MODEL BENTLEY MARK VI

MODIFICATIONENGINE OIL FILLER CAP WASHER.

REPLACEMENT OF TAPPETS.

CATEGORY 2STICKING OF THROTTLE CONTROLS.

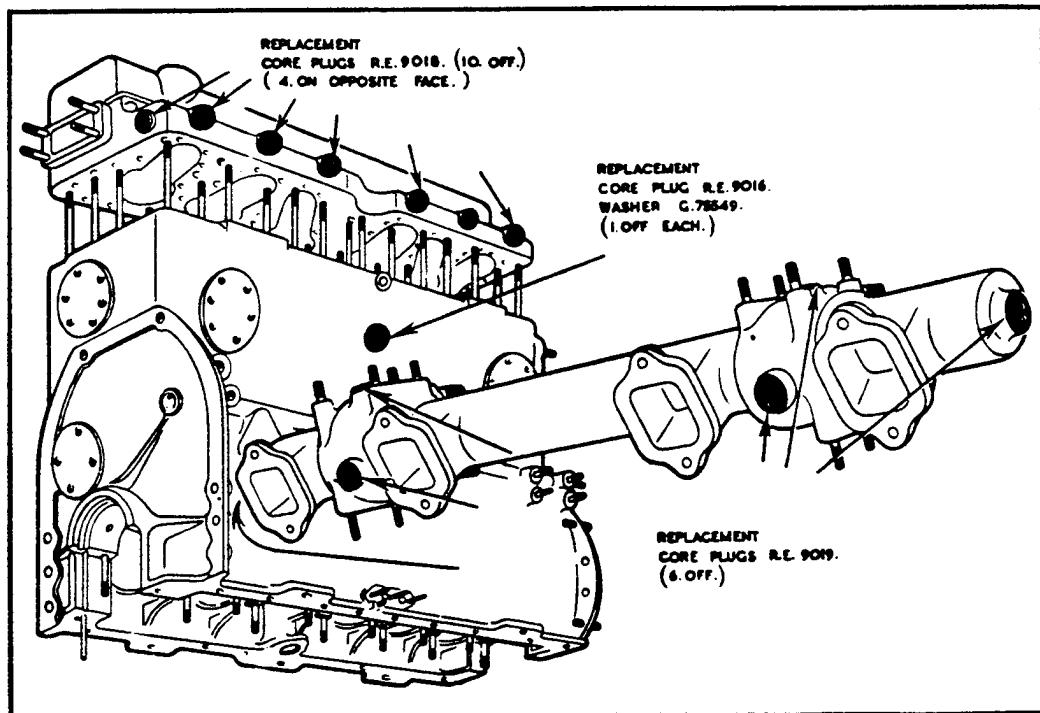
Bentley Service Bulletin BB-19 deals with the replacement of engine core plugs on a Category 2 basis, conditional upon partial or complete overhaul.

The following illustration gives fuller details of the location of the core plugs to be replaced, together with replacement part numbers.

It should also be noted that if a coolant leak develops from any of the core plugs when the engine is fitted with the pre-modified type, this may indicate that a state of corrosion exists in other core plugs caused initially by the engine remaining drained of coolant for lengthy periods of storage or shipment. If a leak is apparent therefore, the instructions given in Bulletin BB-19, limiting this modification to overhaul cases only, must be disregarded, and all core plugs replaced with the modified type.

FIG.1. SECTION - CYLINDER-SHOWING COUNTERBORE.

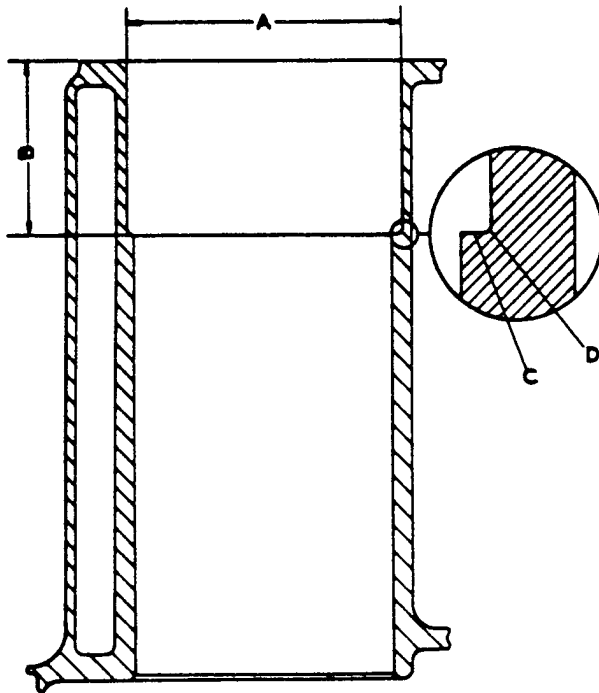
cylinder bore. Next, adjust the boring cutter so that the first cut is heavy enough to get underneath the original chromium plating and counterbore the cylinder to a depth of 2.245" to 2.250" (57.02 to 57.15 m/m). See 'B' Fig.1.

NOTE: If, when measuring the diameter of a counterbore ('A' Fig.1), it exceeds 3.6265" (92.11 m/m), it will be necessary to fit an R-4610 oversize short liner. This liner is marked with white paint and has an external diameter of 3.631" to 3.632" (92.23 to 92.25 m/m), and one should be selected that will not allow an interference exceeding .004" (.1 m/m), or less than .0025" (.06 m/m).

FIG.2. SECTION - CYLINDER - SHORT LINER IN POSITION.

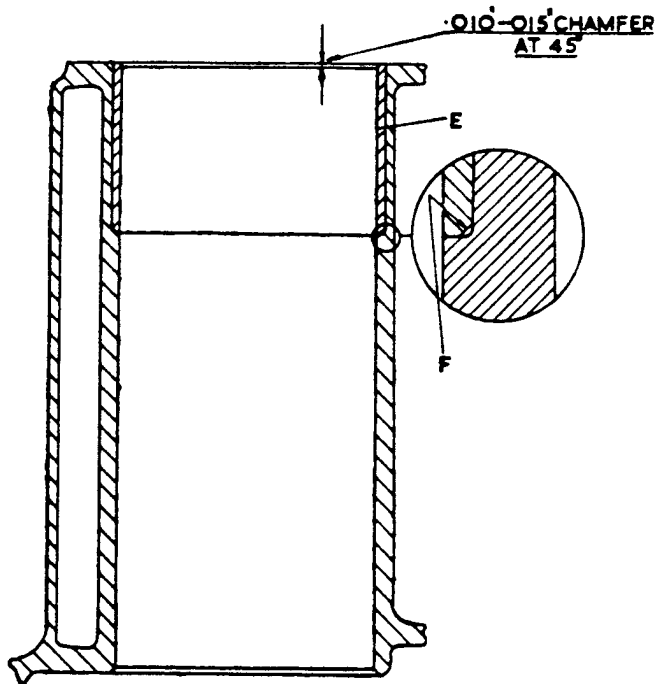
- (ix) With a half-round scraper, cut a .010" to .015" (.25 to .38 m/m) chamfer at about 45° at the upper end of each liner, as shown in Fig.2.
 - (x) If removed, replace the cylinder head holding down studs.
 - (xi) Next, hone the bores to the required standard oversize diameter. (See table 'a' of Para.1). Due to the difference in textures of the liners and the cast iron cylinders, special care should be taken when honing to guard against the possibility of scoring.
3. TO BORE A CYLINDER BLOCK TO A STANDARD OVERSIZE DIAMETER ON WHICH SHORT LINERS WERE ORIGINALLY INCORPORATED (CHASSIS NO. B-144-DA AND ONWARDS):

- (ii) With a half-round scraper, cut a .010" to .015" (.25 to .38 m/m) chamfer at about 45° at the upper end of each liner as shown in Fig.2.
- (iii) If removed, replace the cylinder head holding down studs.
- (iv) Next hone the bores to the required standard oversize diameter.

FIG. 3. SECTION - CYLINDER - TWIN LINERS IN POSITION (3 500" DIA. BORE ENGINE).

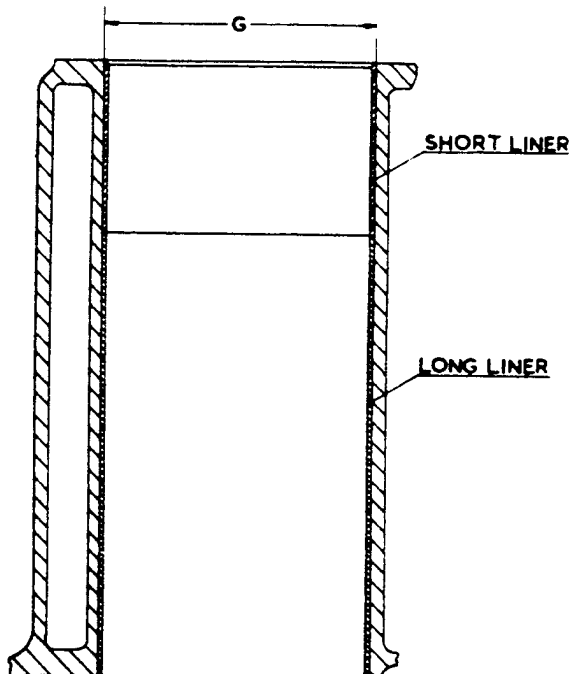
- (vi) Again set up the crankcase on the boring machine with the upper end of the 3.625" (92.07 m/m) dia. counterbore CONCENTRIC with the boring cutter and bore out the cylinder in stages, the whole of its length, (See G Fig.3), to a diameter that will allow the correct interference fit between the cylinder and the pair of matched liners. The finish of the bore must be a MACHINED AND NOT A HONED FINISH, prior to pressing in the liners.

FIG.4. SECTION - CYLINDER-TWIN LINERS IN POSITION (3.625" DIA. BORE ENGINE).

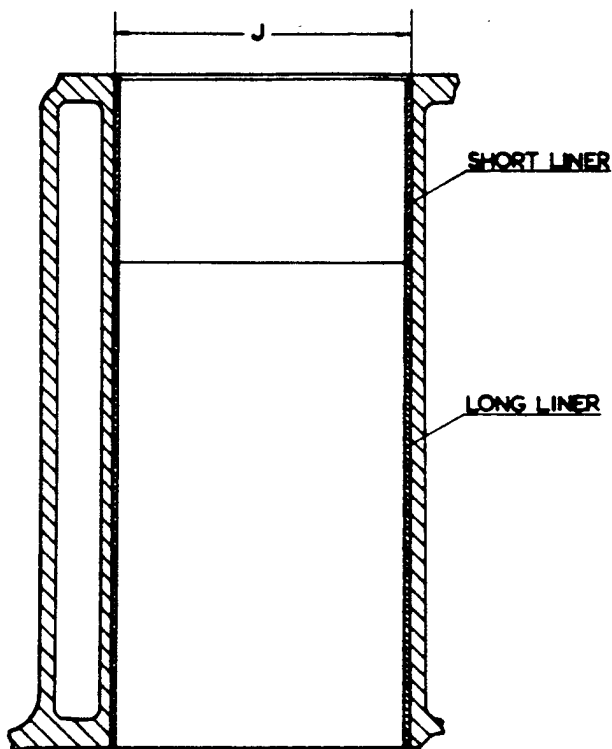
- (iv) Again set up the crankcase on the boring machine with the upper end of the 3.750" (95.25 m/m) dia. counterbore CONCENTRIC with the boring cutter and bore out the cylinder in stages, the whole of its length (See 'J' Fig.4) to a diameter that will allow the correct interference fit between the cylinder and the pair of matched liners.

ROLLED (BOTTOM) FACE.

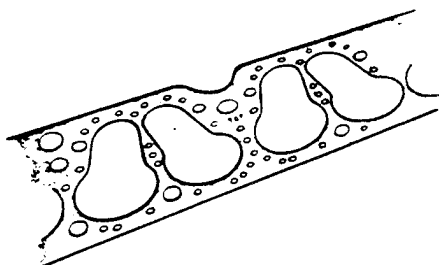
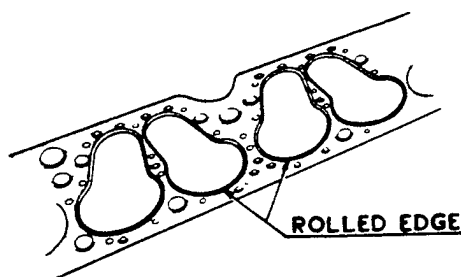
Retailers are advised that the correct procedure when fitting replacement C & A cylinder head gaskets in service is to ensure that these are fitted with the plain face uppermost and the rolled, or lapped, face to the cylinder block.

As an aid to recognition the characteristic differences between the top and bottom faces of the gasket are illustrated in the above two sketches. A further means of identification is provided by the word "TOP" which will be found stamped between Nos. 3 & 4 cylinder openings on the plain face as shown.

FIG. 3. FRONT ELEVATION - FULL FLOW OIL FILTER.

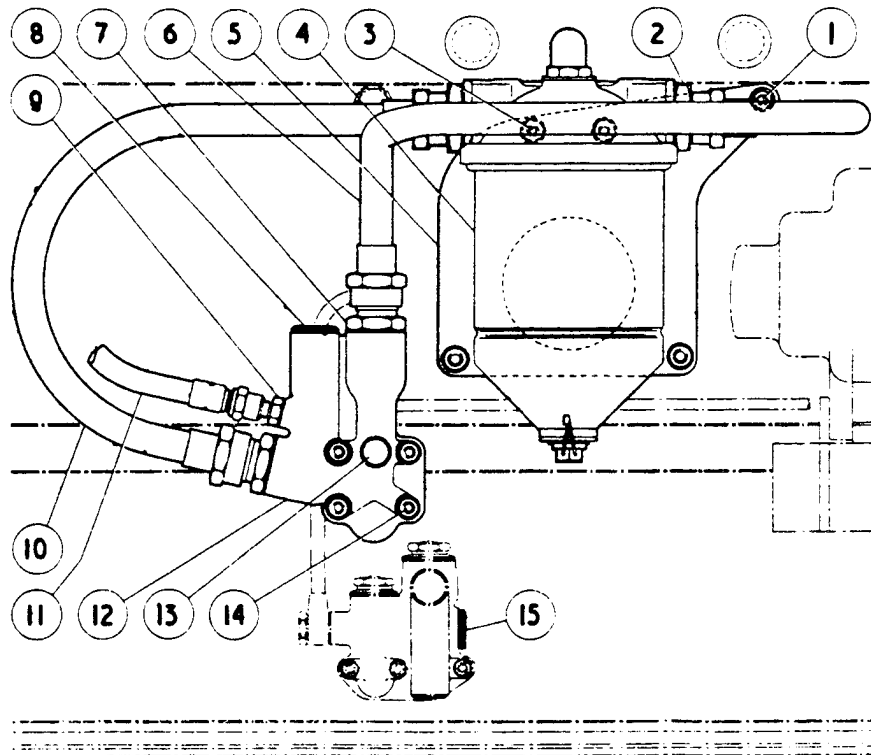
SCHEME 'A' conforms to the layout shown in Fig.3, and is relatively simple in installation, being confined to external alteration only. It can be applied to engines, the crankcase of which have the adaptor facing referred to above. Generally speaking, this modification to the crankcase was first introduced at the commencement of 'H' series to provide a means of employing full flow filtration on unit test, and in anticipation of the scheme becoming standardised later. Crankcases of this type may be recognised by reference to Figs. 1 & 2, which show special adaptors used in conjunction with the original By-Pass Filters.

- File back the face of the lug until the filter mounting plate(5) when offered up to the crankcase lies FLAT against this lug and the two lower studded lugs.

- With the filter mounting plate in position, centralise its two lower holes with the existing studs on the crankcase and temporarily secure in position. Using the mounting plate as a template, mark off the lug and drill a .213"(5.41m/m) dia. hole to a depth of .450"(11.42 m/m) and tap .250" dia. 26 T.P.I.-R.H. Remove the mounting plate and fit the stud(1) KB-751/2. This makes the 3rd fixing point for the filter mounting plate.
NOTE: If the lug referred to above has been machined back, then it will be necessary to fit the circular distance piece, RE-13939, to the stud interposing it between the mounting plate and the lug when carrying out the next operations (v).

FIG. 4. SECTION SHOWING MODIFICATION TO CRANKCASE FOR OIL FEED STANDPIPE.

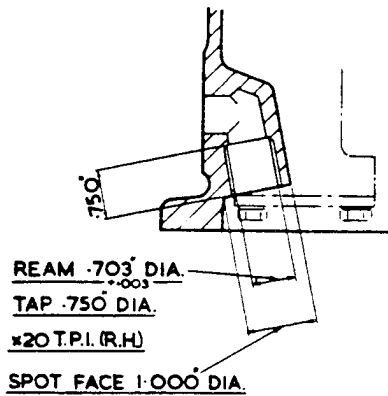
- (i) Remove the oil relief valve overflow pipe, (11/16"dia) from the interior of the crankcase, by twisting to shear the small securing taper pin. With a suitable punch tap out the remaining portion of the pin from the crankcase. For position of pin, refer to point 'A' Fig.7. Remove the sheared portions.
- (ii) Plug the pin hole by first tapping it with the 3-BA taper tap sufficiently to make the screw, K-1813 an interference fit. To prevent the screw protruding into the bore of the overflow pipe hole, shorten it to $\frac{3}{8}$ " (9.5m/m) measured from underside of head. Fit screw and remove head flush with crankcase and finally peen over to secure.
- (iii) With the R-4743 (.703"dia) piloted parallel reamer, ream out the hole in the crankcase from which the overflow pipe has been removed and tap .750"dia 20 T.P.I.-R.H. using both taper and plug taps(See Fig.4).

FIG. 8. SCRAP VIEW SHOWING CRANKCASE LUG ('A').

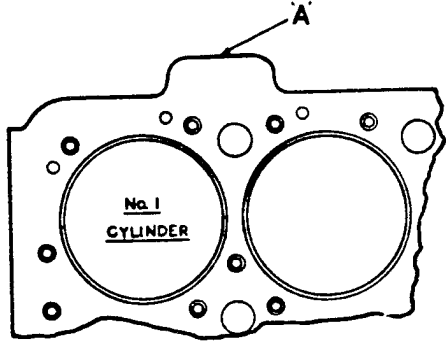
- (vi) File back the face of the crankcase front lug, 'A' Fig. 8 and fit the stud (1) KB-751/Z as described in sub-para. (iv) of Para. 3 for Scheme 'A'.

FIG. 9. FRONT ELEVATION - FULL FLOW OIL FILTER.

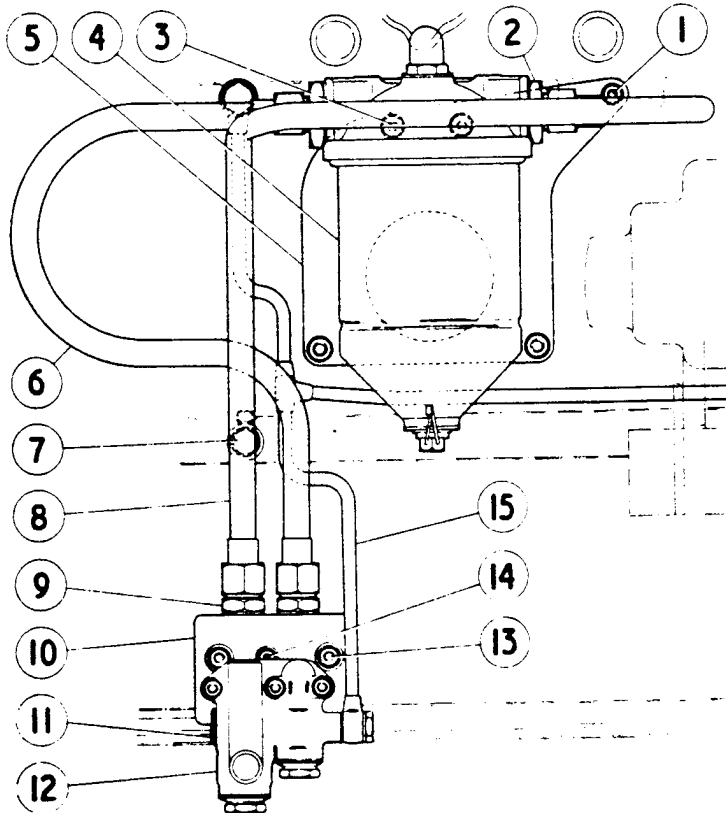
(x) Fit the three studs, 18 (2-BA x 1.600" long) to the transfer block (10 Fig.9), also the two adaptors (9) and joint washers. Place the block complete with its Vellumoid joint R-4497, on to the crankcase.
 NOTE: As the joint is similar to the joint (EB-3953) for the oil relief valve unit except for a .375" (9.52m/m) diameter hole in the former, it is important the the CORRECT joint is fitted. Place an aluminium washer only on to each of the three studs and secure. (NO OTHER WASHERS ARE REQUIRED).

(xi) Remove the union from the oil relief valve unit and fit the core plug (11) and joint washer. Place the unit and the Vellumoid joint (EB-3953) on to the transfer block. While tightening up the three nuts to secure, check that the end of the centre stud (14) or nuts securing the transfer block to the crankcase do not foul the casing of the oil relief valve unit. The unit is inverted for fitting under this arrangement as shown in Fig.9.

FIG. 11. CRANKCASE LOWER HALF.

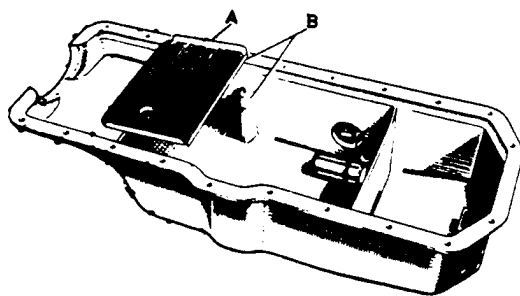
- (xiii) When offering up the lower half of the crankcase, it will be found that the union nut securing the oil feed pipe to the standpipe (21) fouls the oil baffle ('A' Fig-11) and the locating lug at points 'B'. Remove the baffle and file the lug until it just clears the nut and then file the edge of the baffle to suit. It may also be necessary to file the inside of the lower half of the crankcase to clear the nut. Refit the baffle.

FIG.1 LOCATION OF CORE PLUGS

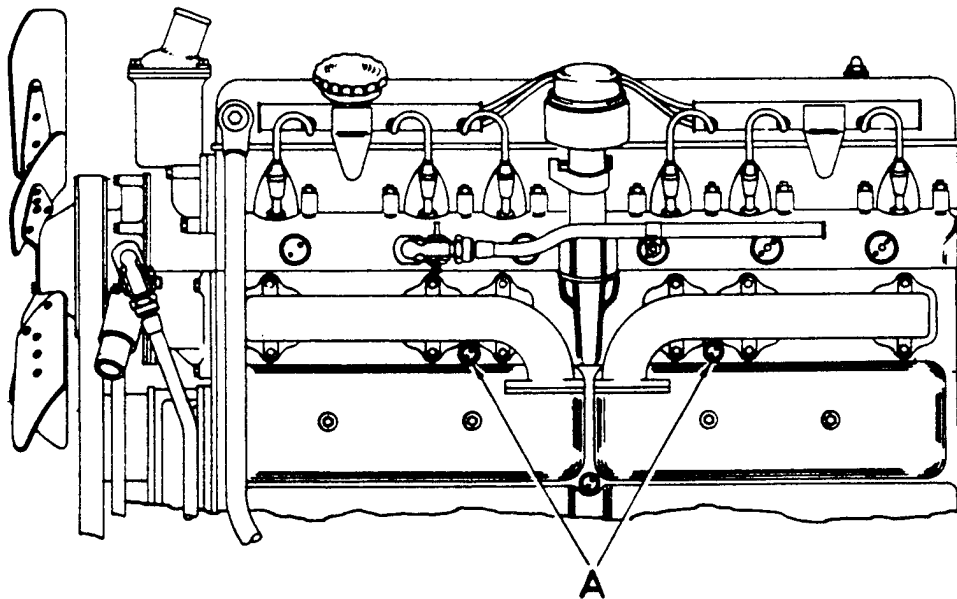
On certain $\frac{3}{8}$ " bore engines two aluminium alloy core plugs were fitted on the left hand side of the crankcase above the tappet covers as shown at A Fig.1.

The aluminium plugs have proved subject to corrosion in service and are to be replaced with cadmium plated steel core plugs and aluminium washers as a retrospective modification. Retailers are asked to carry out replacement on all affected cars in their area when they are next being serviced.

- (i) Drain the cylinder block.
- (ii) Remove the aluminium core plugs, clean the threads with the tap provided and fit the steel plugs and aluminium washers.
- (iii) Refill the cooling system.

FIG.1.
RADIUS ON FLYWHEEL TEETH.

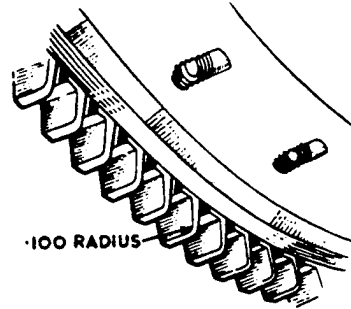
The flywheel ring gear teeth are also to be radiused .100" (2.54 mm) to remove the sharp corner on the engaging face.

- (i) Remove the starter motor complete. Remove the starter drive assembly from the motor and refit the new drive assembly.
- (ii) Remove the flywheel lower cover and radius the flywheel teeth with a medium file as shown in Fig.1.
- (iii) Refit the starter motor and flywheel lower cover.

Fig.1 Outer Lip Proud of Inner Sealing Face.

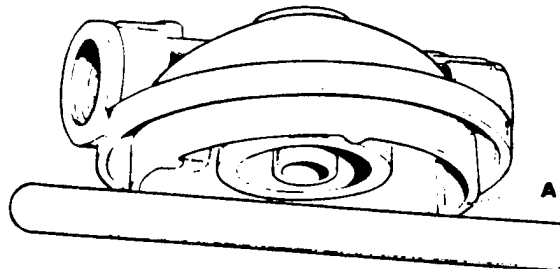
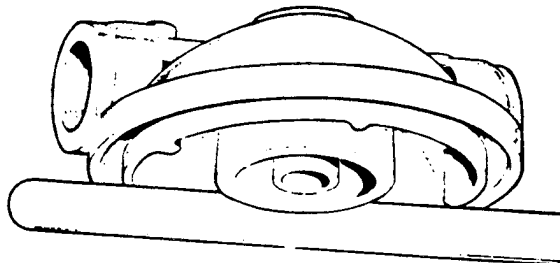
It has been established that on a small number of 'Vokes' Full-Flow Oil Filters it is possible for the oil to pass across the filter head without passing through the filter element. This condition is only possible when the outer lip of the filter head (see A Fig.1) stands proud of the inner sealing face.

Therefore when the bowl of the filter is removed to change the filter element and seals, on the 5,000 miles service schedule, Retailers should check the filter head with the aid of a straight edge as illustrated in Figures 1 and 2.

If the outer lip is found to stand proud of the inner sealing face (see Fig.1), a modified 'Top Cap' (see Fig.3) should be fitted and the original discarded.

If the inner sealing face stands proud of the outer lip (see Fig.2) the original 'Top Cap' (as shown in Fig.4) can be retained. For future replacements only the modified 'Top Cap' will be supplied.
